DEVELOPMENT REVIEW BOARD REPORT

CASE NUMBER/ PROJECT NAME	88-DR-2005#2 Skysong Residential (Phase III)		
LOCATION	Southeast corner of Scottsdale and McDowell Roads		
REQUEST	Request approval of a site plan and parking structure location as part of the overall Skysong Planned Community District. This site plan would specifically approve the footprint of the proposed parking garage and set a perimeter development boundary line for the proposed residential development.		
OWNER	City of Scottsdale 480-312-7064	ENGINEER	Wood Patel Engineering 480-834-3300
ARCHITECT/ DESIGNER	Todd & Associates, Inc. 602-952-8280	APPLICANT	Higgins Plaza Development Partners 312-943-4999
BACKGROUND	<p>Zoning.</p> <p>The site is zoned Planned Community District with amended development standards (PCD), which allows research and development, general office, retail, medical office, government, residential, and service related uses.</p> <p>Context.</p> <p>The site is located on the southeast corner of the intersection of Scottsdale Road and McDowell Road.</p> <p>Adjacent Uses:</p> <ul style="list-style-type: none">• North: A mixture of commercial, retail, office, and auto dealership land uses in the C-3 & C-4

SITE PLAN

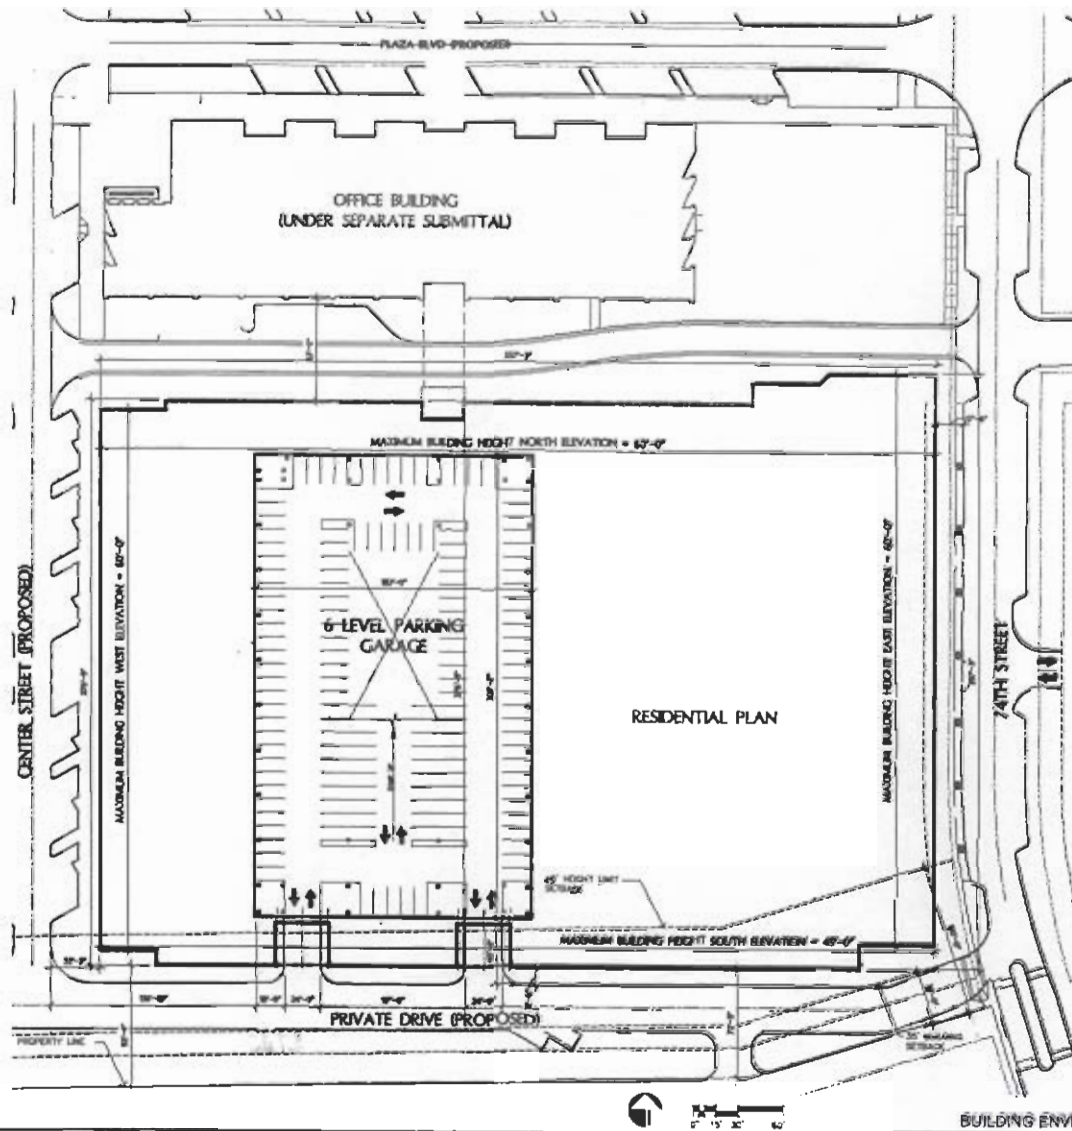
8 LIVES, WARRING GARAGE, FOOTPRINT
SUBMITTED FOR SPECIFIC APPROVAL, WITH
THIS SITE PLAN.

OUTER RESIDENTIAL DEVELOPMENT
BOUNDARY LINE. NO DEVELOPMENT WILL
EXCEED THIS BOUNDARY LINE, AND ALL
FUTURE RESIDENTIAL IMPROVEMENTS WILL BE
SUBJECT TO FUTURE DRB REVIEW AND
APPROVAL.

2. *This approval is for the building envelope of the residential component and the footprint of the garage improvements only. No design elements, architectural elements, or elevations are included in this approval.*

3. *The required parking for the residential project shall be provided in the parking structure.*
4. *No permits for the garage shall be issued until after the residential project has received Development Review Board approval. Additionally, if a residential project is not constructed, the applicant must submit for, and receive, Development Review Board approval for the elevations of the parking structure.*
